UNITED STATES PATENT AND TRADEMARK OFFICE

APPLICATION NO.	FILING DATE	FIRST NAMED INVENTOR	ATTORNEY DOCKET NO.	CONFIRMATION NO.
10/088,050	08/12/2002	Dany Ray	Q68978	6570

Office Action Summary	Application No. 10/088,050	Applicant(s) RAY ET AL.	
	Examiner Frederick C. Nicolas	Art Unit 3754

FIG. 2

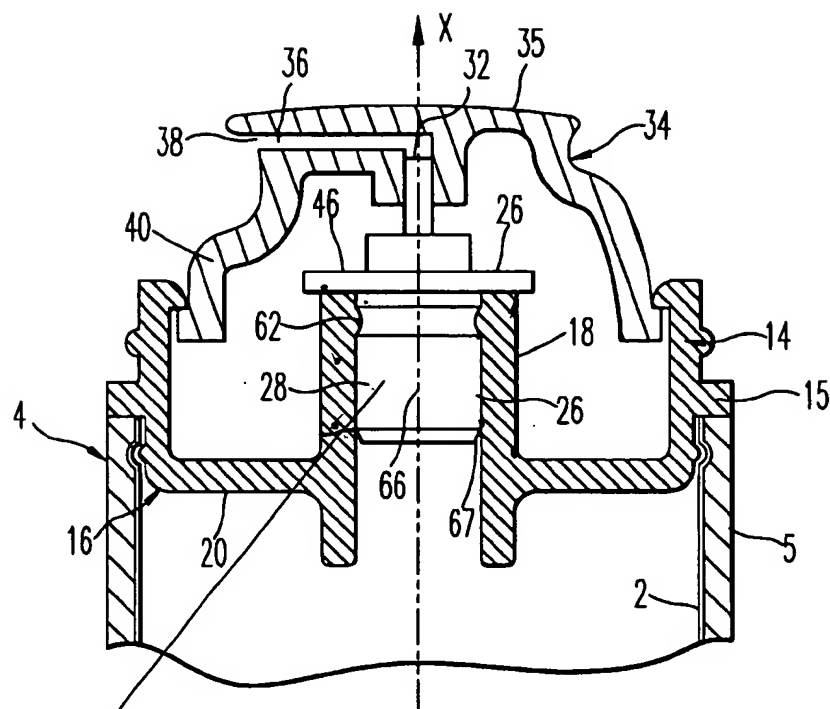
Gueret discloses a fluid dispenser device designed to be mounted on the neck of a receptacle (4) as seen in Figure 2, which comprises a dispensing member (26), fixing means for fixing the dispensing member to the neck of the receptacle (col. 4, ll. 27-67), the dispensing member comprises a body (28) whose top end is provided with a collar

(46) that projects outwards, the fluid dispenser device being characterized in that the fixing means comprise a substantially cylindrical ring (18) engaged on the body under the collar as seen in Figure 2, the ring being in peripheral leaktight contact with the body by being radially clamped thereon (col. 6, ll. 47-48), the ring defines a top end in abutment under the collar as seen in Figure 2, the body also forms at least one outwardly-projecting bulge situated below the collar (46) see attached Figure 2 for location of the at least one outwardly-projecting bulge, the ring being disposed between the collar and the at least one bulge so that the ring is locked therebetween as seen in Figure 2, the free top end of the ring is provided with an inside bevel to make it easier for the ring to pass over the bulge (col. 5, ll. 34-46 and as seen in Figure 2), a radial flange (20) serving into abutment against the neck of the receptacle, a socket (16) being extended downward and configured to be crimped (col. 4, ll. 11-26).

at least one
outwardly-trajecting
bulge 4
